**SAC 30634
Temporary Ground Boarding Walkways
Addendum No. 1**

Changes to Drawings –Updated sheets E0.01 and E1.00

TERMINAL CONCOURSE TEMPORARY
GROUND BOARDING

SHEET TITLE
ELECTRICAL LEGEND, GENERAL NOTES
AND SPECIFICATIONS

SHEET NO.
E0.01

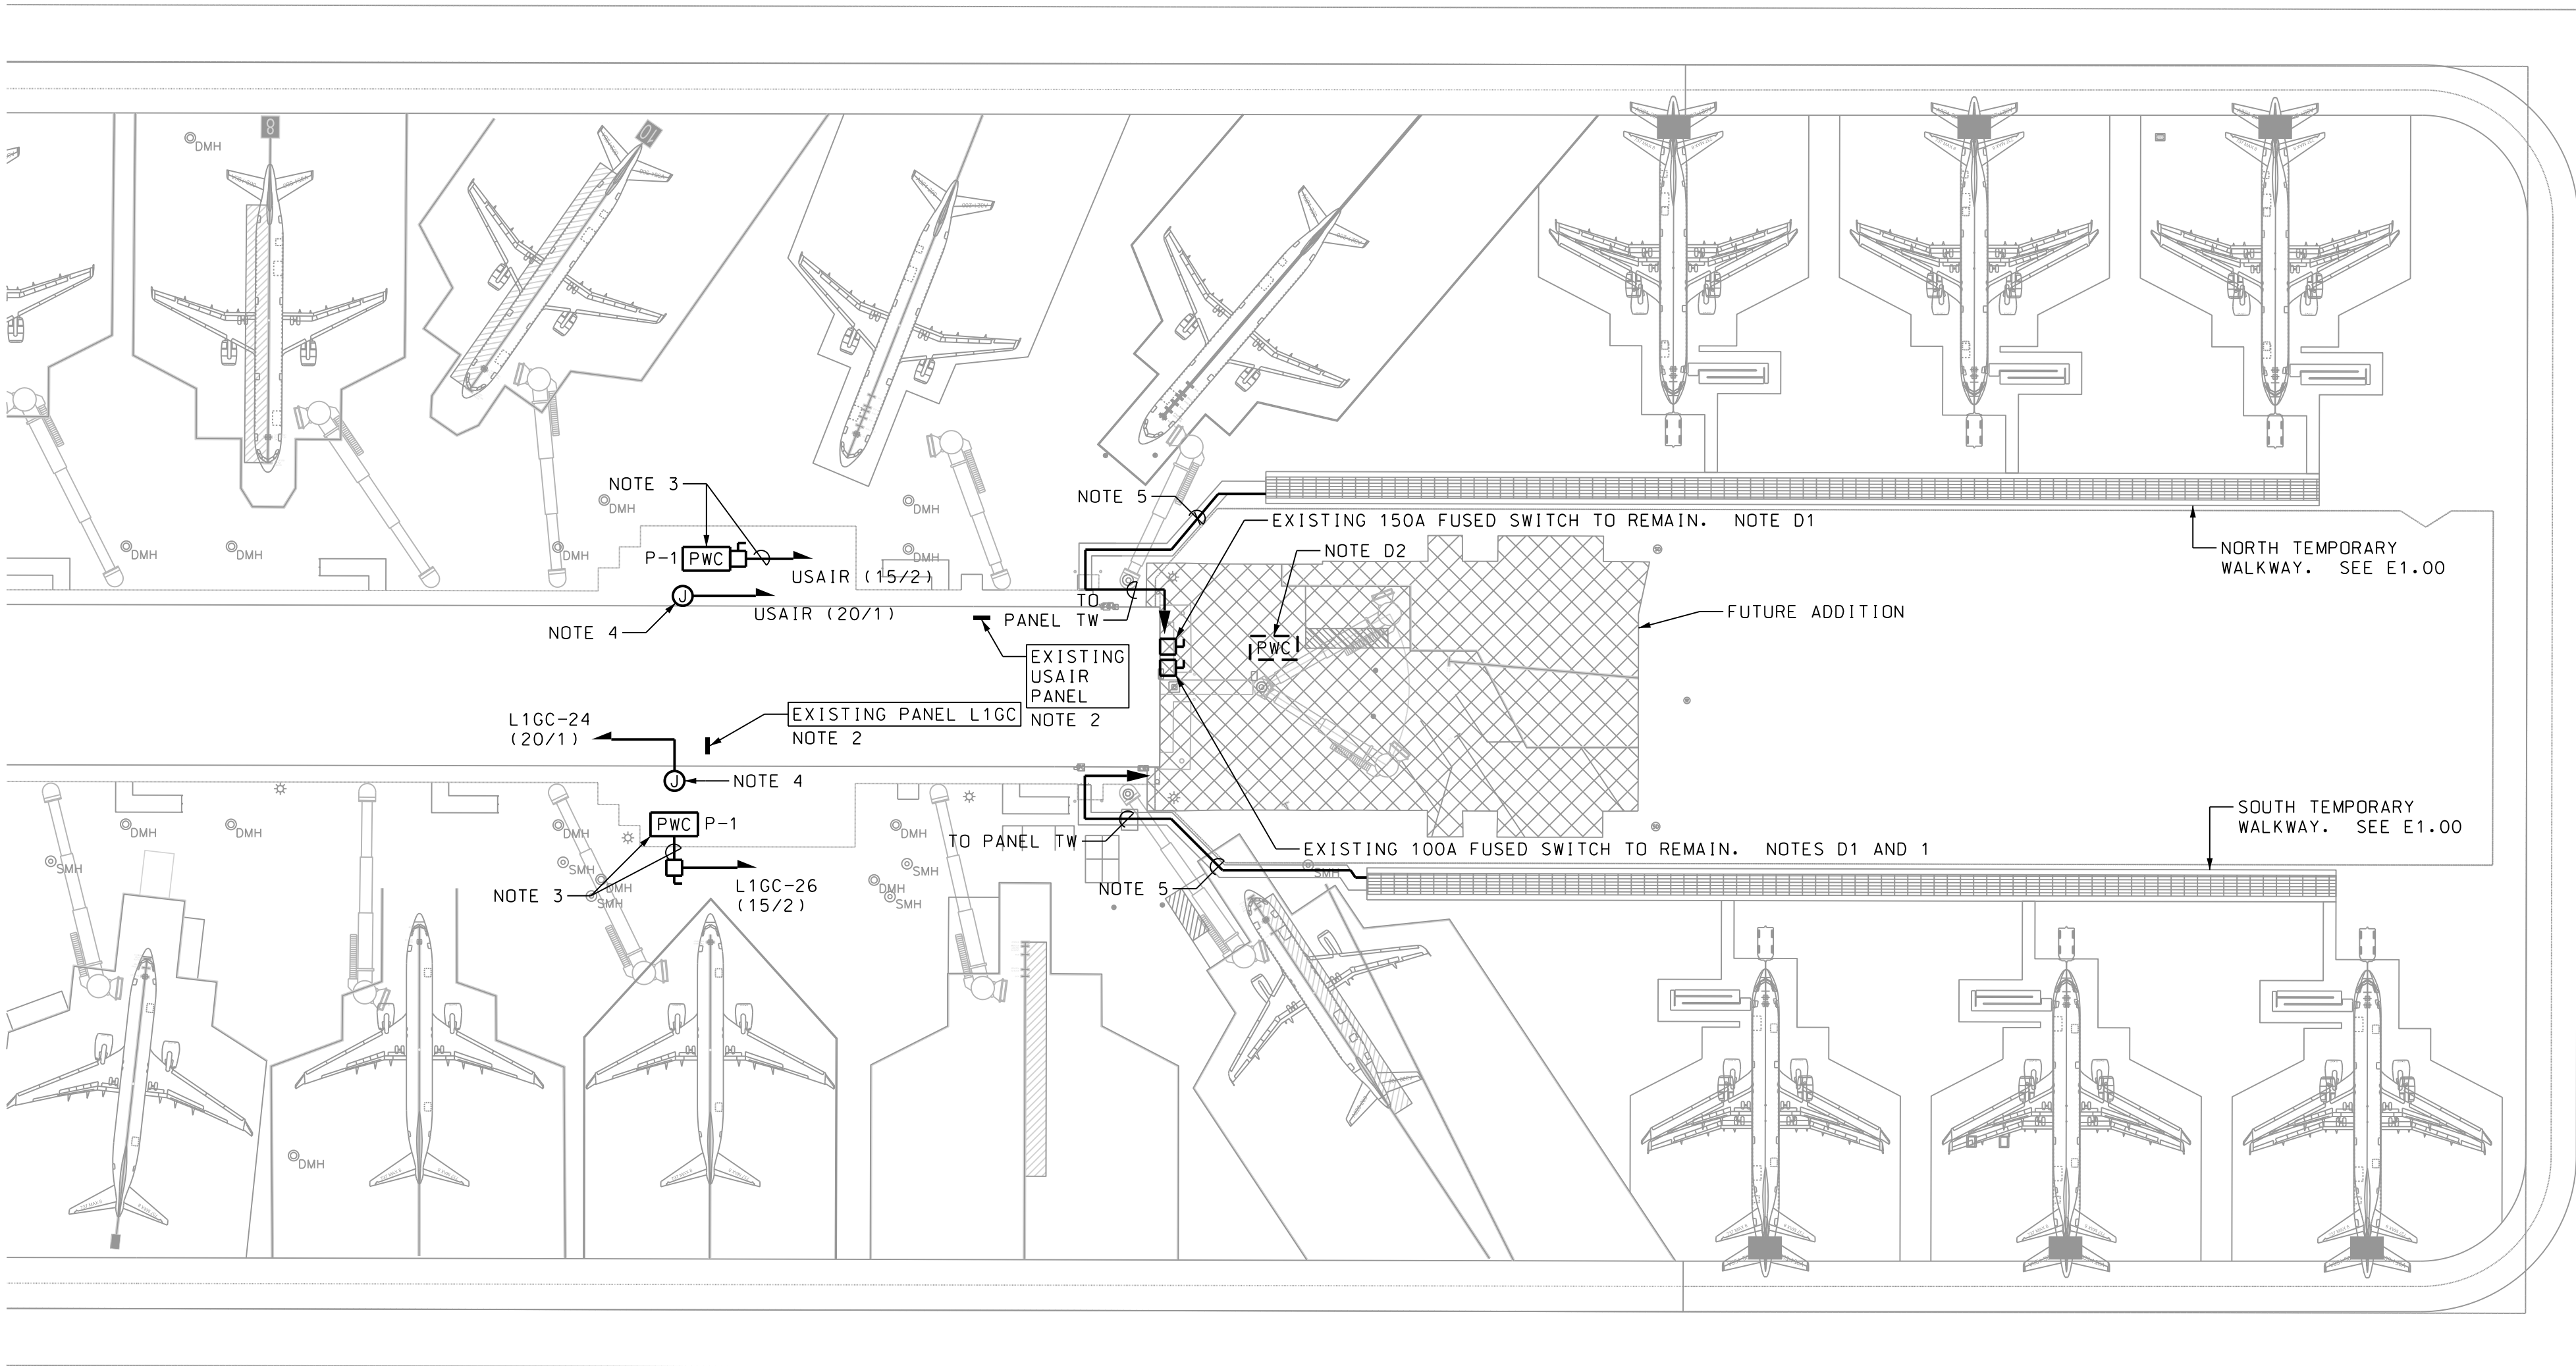
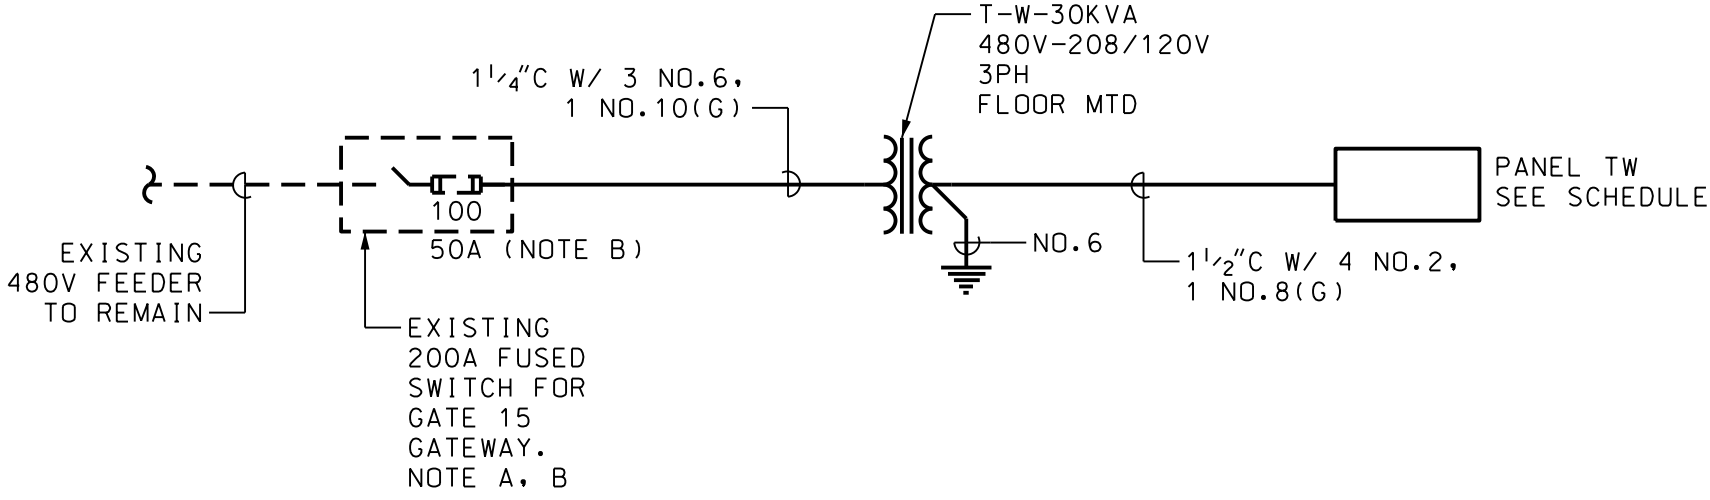
- A. REMOVE SERVICE TO GATEWAY 15 AND USE SWITCH FOR TEMPORARY WALKWAY SHOWN.
- B. REPLACE 3 - 100A FUSES WITH 3 - 50A FUSES.
